UNITED STATES PATENT AND TRADEMARK OFFICE

10/669,740

Office Action Summary

DETAILED ACTION

Buono '644 Figure 3

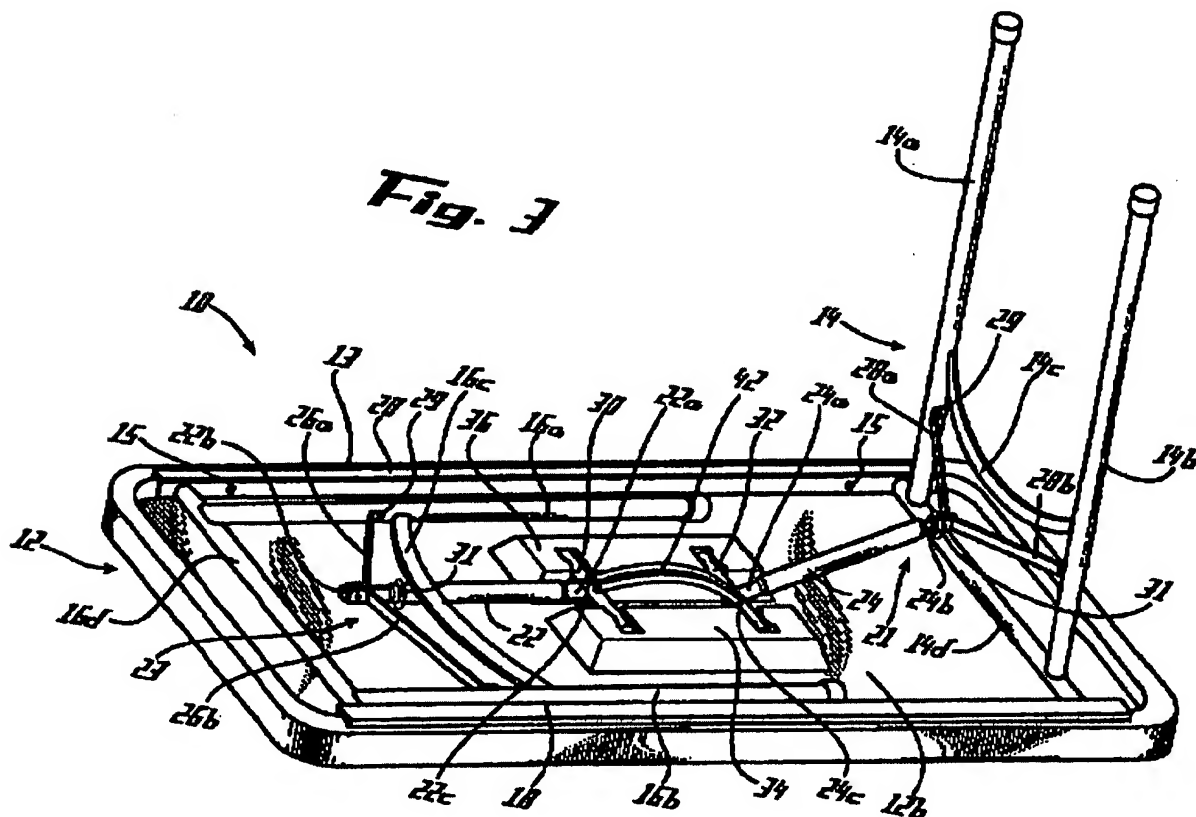
2. Claims 1 and 3-8 are rejected under 35 U.S.C. 102(e) as being anticipated by U.S. Patent U.S. Patent 6,622,644 to Buono. Buono'644 discloses a table (10) with a table top (12). The table top (12) has a top surface (12a) and a bottom surface (12b). A mounting structure (34,36) is centrally disposed on the bottom surface (12b). A support assembly (21,23) is partially connected to the mounting structure (34,36). A frame assembly has a first leg (14), which is attached to the first end of a support brace (28). The second end of the support brace (28) is attached to the support assembly (21,23).

The pair of spaced apart side rails are formed integrally in the mounting structure (34,36). A first cross bar (32) or end rails (30,32) are disposed transverse to the side rails and attached there between. One of the end rails (30,32) is connected to the table leg (14). The support assembly is integrally formed with the table top as seen in figure 3. The mounting structure (34,36) and table top (12) are formed of blow-molded plastic (col. 1, line 35-38). The frame assembly has a pair of spaced apart side rails (18,20) and a pair of spaced apart end rails (14d, 16d) are disposed transversely to the pair of side rails (18,20) and connected between so that the table leg (14) is connected to one of the end rails (14d).
